**JOINT REGIONAL PLANNING PANEL
(Sydney West Region)**

JRPP No.	2014SYW166
DA Number	DA/799/2014
Local Government Area	Parramatta City Council
Proposed Development	Demolition, tree removal and construction of an office building, Chancery building and a Parish Hall and associated basement parking on Lot 1 D P 1034092 and construction of a part 5 part 6 storey residential flat building, comprising 77 units with two levels of basement parking on Lot 5 DP 1182647.
Street Address	No.1 Marist Place & No.26 O Connell Street, PARRAMATTA
Applicant/Owner	The Catholic Diocese of Parramatta/ Trustees Roman Catholic Church
Number of Submissions	No submissions
Regional Development Criteria (Schedule 4A of the Act)	Pursuant to Clause 3 of Schedule 4A of the Environmental Planning and Assessment Act 1979, the development has a capital investment value of more than \$20 million
List of All Relevant s79C(1)(a) Matters	State Environmental Planning Policy No. 65, State Environmental Planning Policy No. 55, State Environmental Planning Policy (Infrastructure) 2007, Sydney Regional Environmental Plan (Sydney Harbour Catchment) 2005, Parramatta Local Environment Plan 2011.Parramatta Development Control

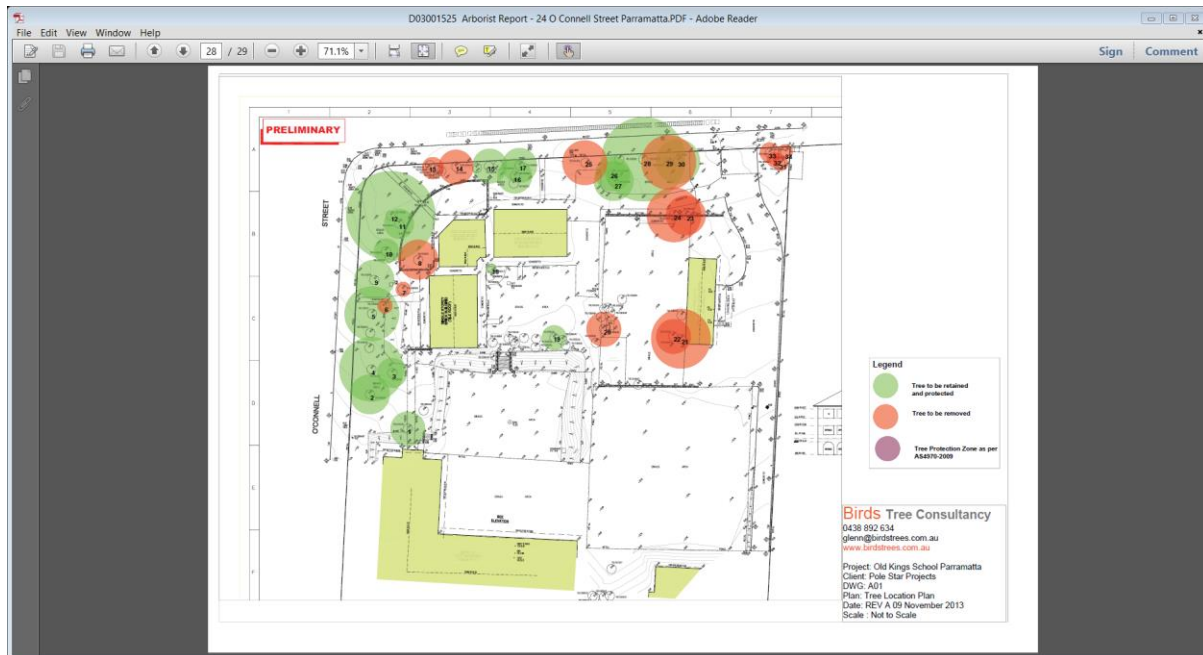
Of note when assessing the previous contamination report against the proposed redevelopment, was that BH10 & BH8 had elevated Arsenic levels (Possibly, historically, used as an insecticide in this instance). These bore holes are located nearest to the O'Connell St boundary of the proposed redevelopment. The area to be excavated for remediation is wholly contained within the proposed site boundaries. The contaminated soil depth is expected to only be 0.8m and so will not impact on the groundwater table. The trees in this area are shown to be retained within the landscaping plan and there is a question as to whether they will be impacted by the soil remediation works. This area will also be used as the courtyards for a few of the ground floor apartments, once completed. Further testing will take place once the contaminated soil is excavated to ensure that any soil containing levels that breach NEPM guidelines for the proposed final use of the site are removed safely and responsibly.

This image indicates the trees to be retained.

This image indicates the likely extent of the area requiring decontamination.

The above image, taken from D03001525 Arborist Report - 24 O Connell Street Parramatta 10/12/2013 at 9:40 AM, shows the arborist’s previous report for DA/817/2013, which indicates that there would likely be sufficient room to safely remove the arsenic contaminated soil without impacting on any of the trees identified to be retained.
